Please insert the following note into the instruction manual before proceeding with the construction of the Lancair.

Before performing Step 1 of "Join the Wings" on page 12 of the instruction manual, read the following Note #1.

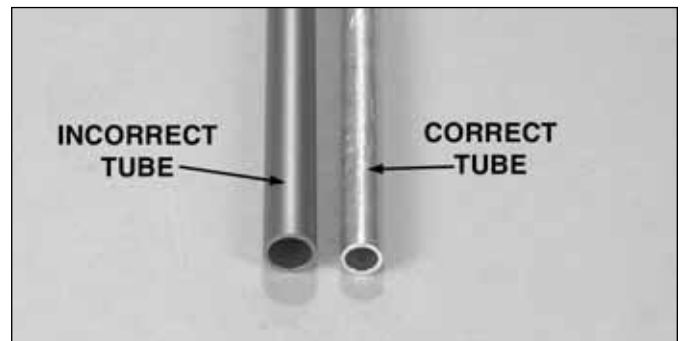
Before performing Step 10 of "Install the Nose Wheel" on page 20 of the instruction manual, read the following Note #3.

Note #3. Your kit may contain two nose gear wires. At first glance they may appear the same but one may be incorrectly bent. Look at them closely and compare them to the following photos. Be sure to install the correct nose gear wire as shown below. The remaining wire can be discarded.
